FIELD OBSERVATION REPORT
Price Structural Engineers, Inc. (PSE)

Project: 3 – Unit Apartment
Location: 62 Cumberland St.; Portland, ME
Date: Apr. 29 & May 10, 2011
Time: 11:00 AM

Final Structural Site visits

Photo #8 – Guardrail post base reinforcement

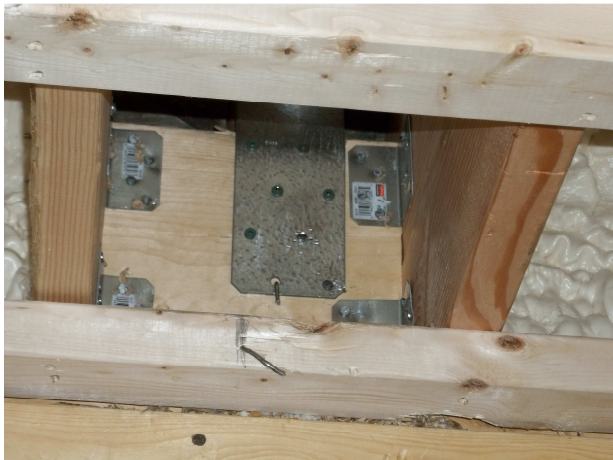
1. A double 2x10 beam supporting the front porch was supported at the east end near the steel column at B/2 by a column underneath, see attached photos.
2. Pressure -treated door jambs were observed adjacent to the garage door openings, see attached photos.
3. Guardrail post anchorage connections were reinforced, see attached photos.
4. The stair stringers at the primary stair were relocated and connected directly to the existing VLAM beam with approved hangers, see attached photos.
5. The beam extending between grid B/5 and B/6 was reinforced with a Versalam sister, see attached photos.
6. The triple 2x beam at the west side of the elevator was connected with beam hangers at each end, see attached photos.
7. The center stringer leading to the 3rd floor had a ledger underneath at the connection near the top of the stair, see attached photos.
